ORIGINATION FORM

Proposed Revisions to a Standard Plans Index
(Please provide all information — Incomplete forms will be returned)

Index Number: 509-100
Sheet Number (s): 1 of 1
Index Title: Advance Warning For R/R Crossing

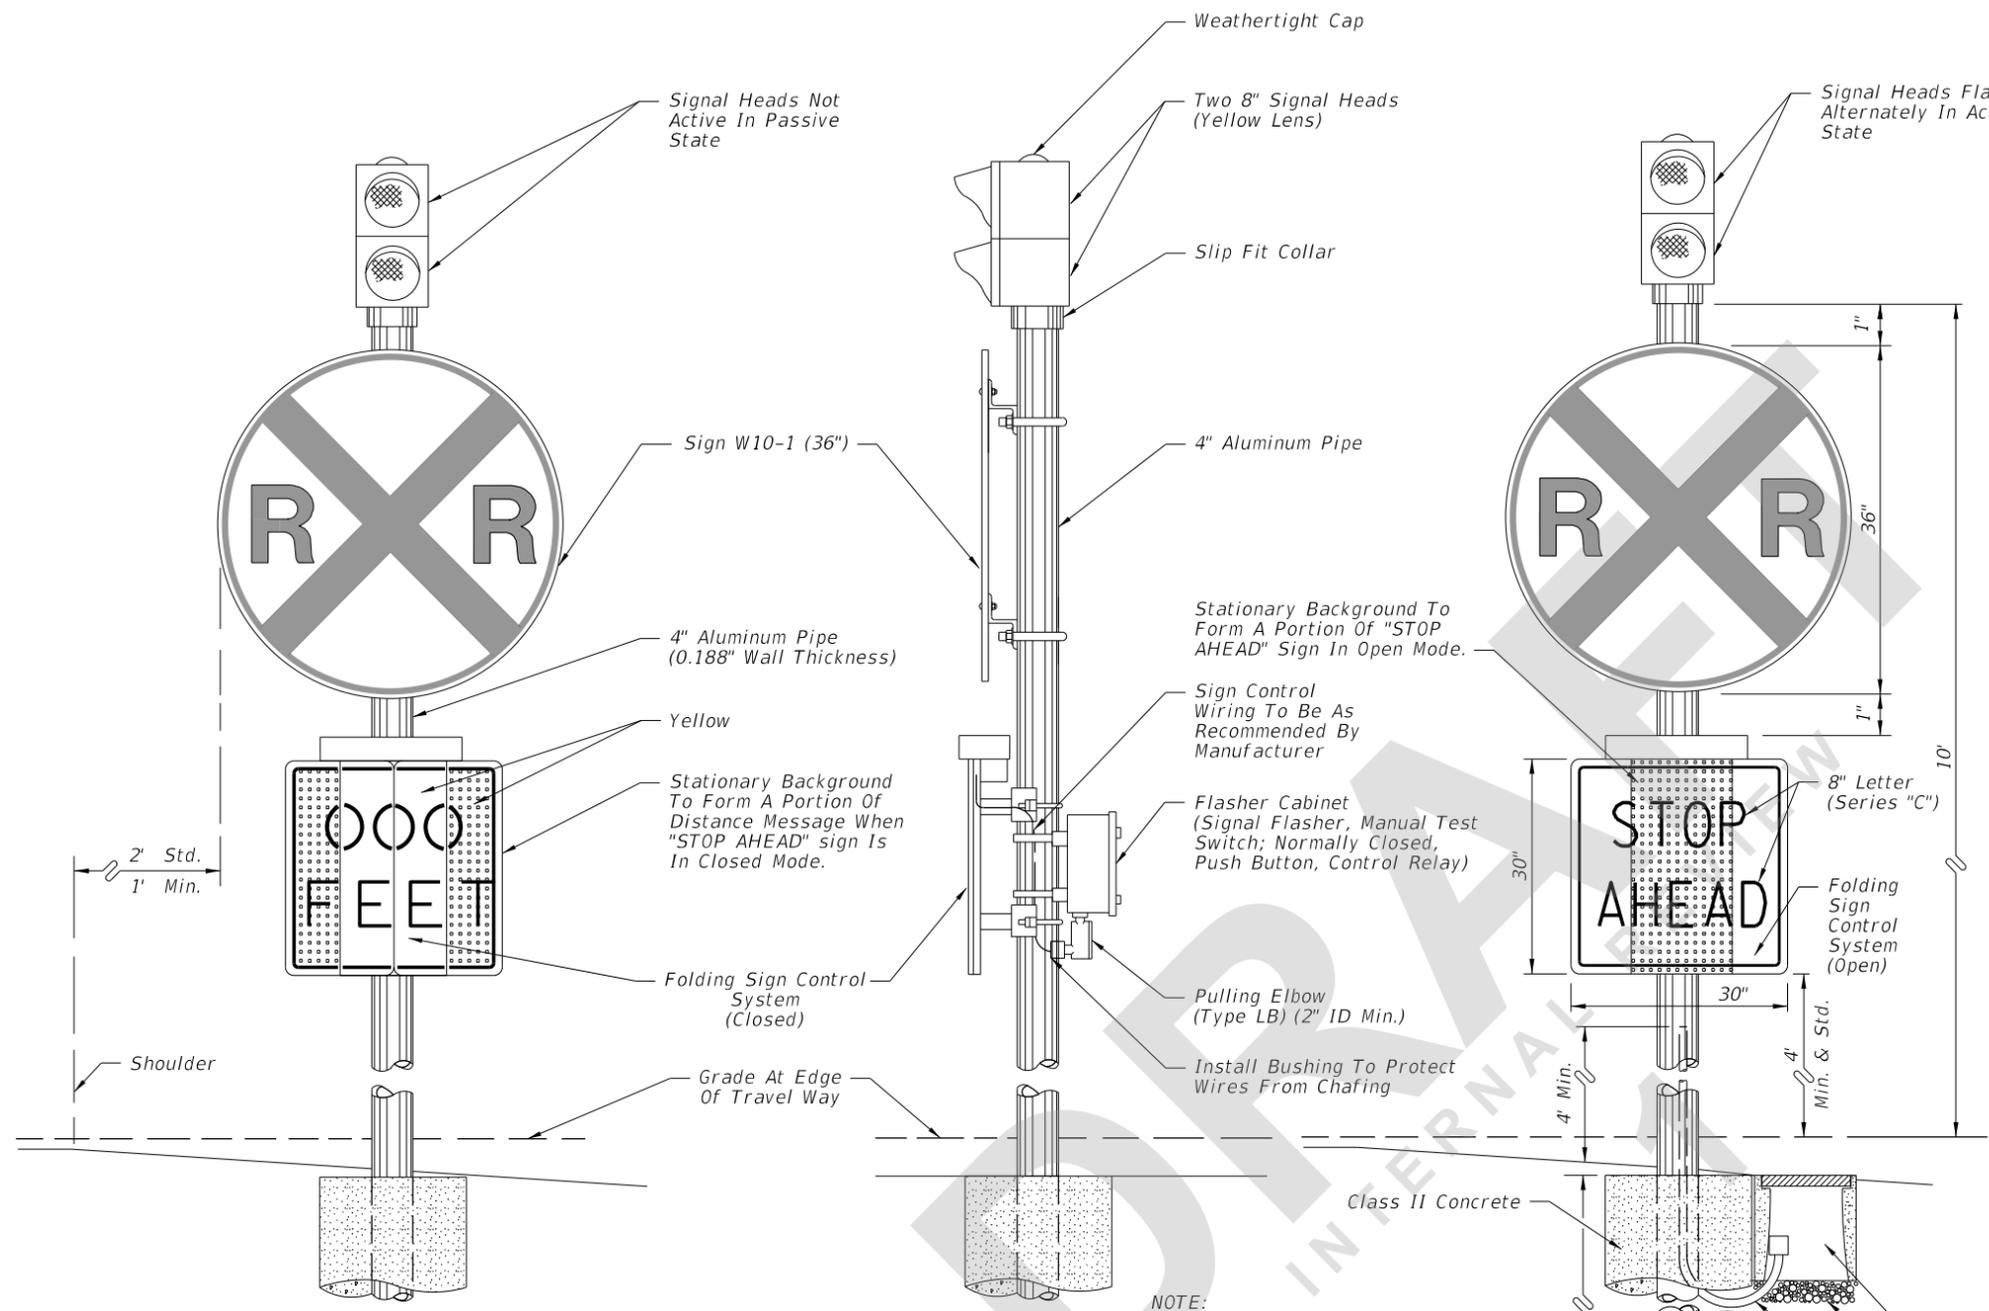
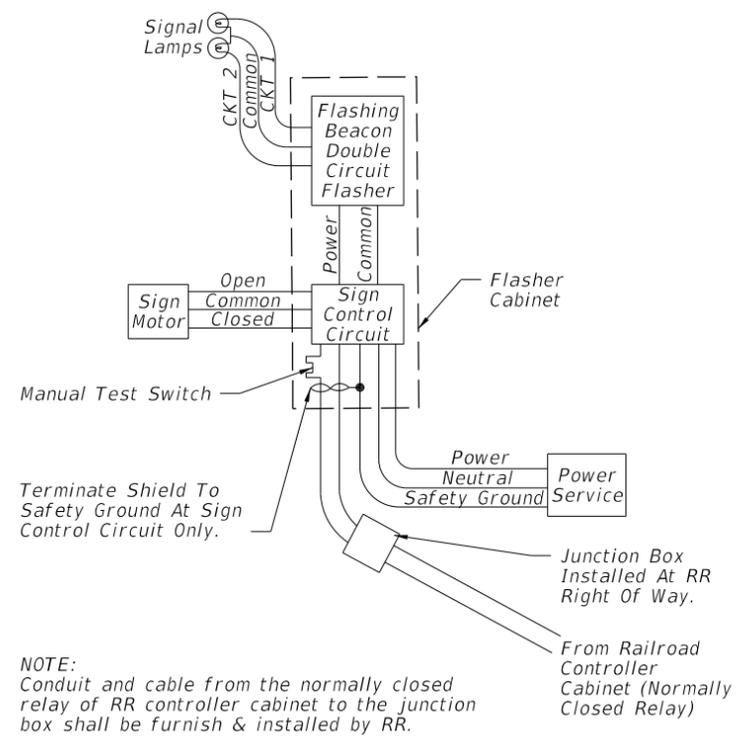
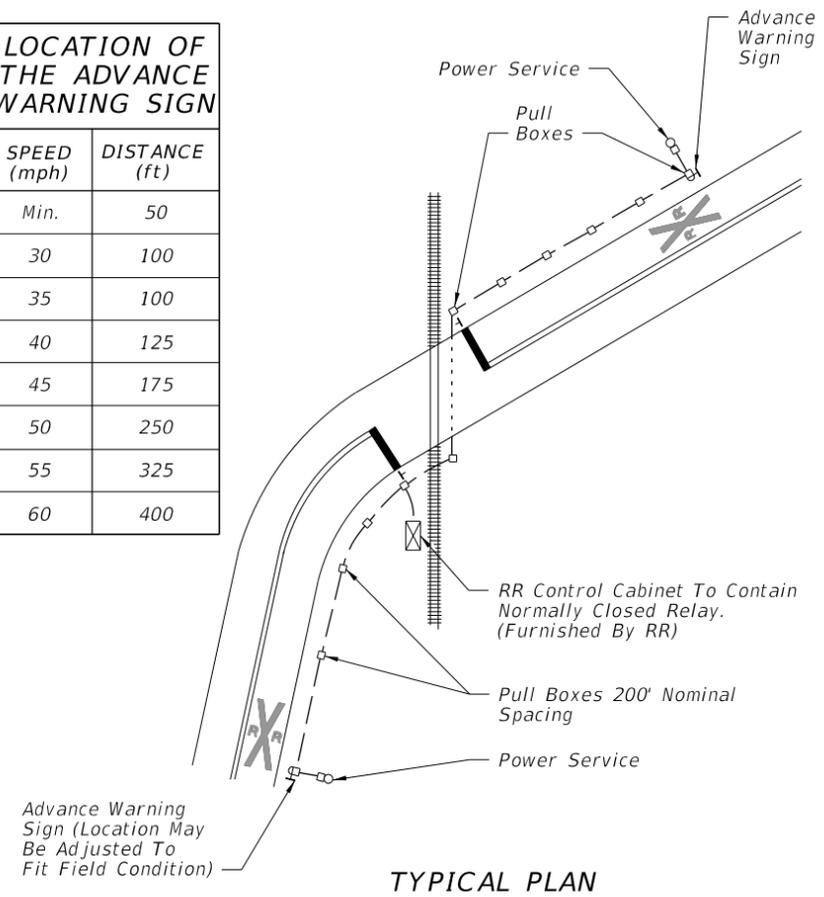
Sheet 1: Changed "Class I" to "Class II" in the Front View of the ACTIVE STATE Detail.

CHANGED TO: Class II

Changed to reflect Materials specification change that removes the designation for Class I Concrete.
